REPORT

NEW AIR TRAFFIC SERVICES CENTRE AND CONTROL TOWER, PERTH AIRPORT

(Twelfth Report of 1981)

site plan

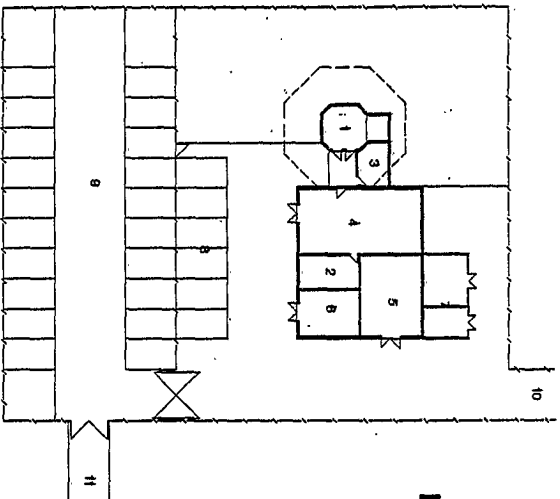
49. Several important factors were taken into account when the site for the Control Tower was chosen but all these factors related to the present or the short term future. The Committee, for reasons already outlined, cannot endorse the site chosen as it has not been considered in terms of the Master Plan which covers long term development. The situation is clearly exemplified at page 23 of the Department of Transport's evidence where it is stated: "... the area selected is the only one which adequately meets all operational requirements". Consequently the site may need to be re-examined when the Master Plan becomes available.

52. Committee's Recommendations The sites selected are suitable. The site proposed for the Control Tower may need to be re-examined when the Master Plan becomes available.

5. THE SITES SELECTED ARE SUITABLE. THE SITE PROPOSED FOR THE CONTROL TOWER MAY NEED TO BE RE-EXAMINED WHEN THE MASTER PLAN BECOMES AVAILABLE. 52
6. DISCUSSIONS WITH THE WESTERN AUSTRALIAN GOVERNMENT SHOULD BE RE-OPENED WITH A VIEW TO SETTING UP THE WESTERN AUSTRALIAN AIRFIELDS COMMITTEE WITHIN SIX MONTHS. 61

elevation
CONTROL TOWER

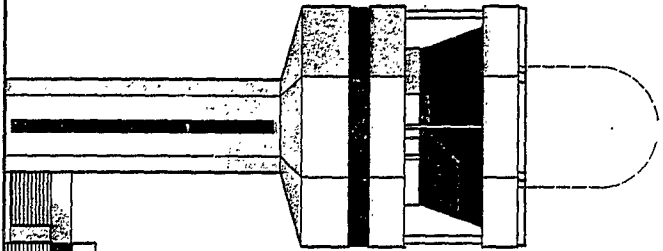
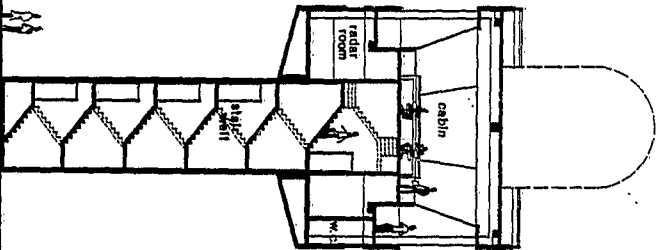
47. Committee's Conclusions The design of the proposed work, with the exception of the Control Tower, is satisfactory. The Control Tower may need to be redesigned after production of the Perth Airport Master Plan to ensure it is suitable, without major rebuilding, for whatever the final development options may be. The Committee recommends that detailed planning of all the works in this reference should proceed to minimise potential delays should no changes to the Control Tower be required.

3. THE DESIGN OF THE PROPOSED WORK, WITH THE EXCEPTION OF THE CONTROL TOWER, IS SATISFACTORY. THE CONTROL TOWER MAY NEED TO BE REDESIGNED AFTER PRODUCTION OF THE PERTH AIRPORT MASTER PLAN TO ENSURE IT IS SUITABLE, WITHOUT MAJOR REBUILDING, FOR WHATEVER THE FINAL DEVELOPMENT OPTIONS MAY BE. 47
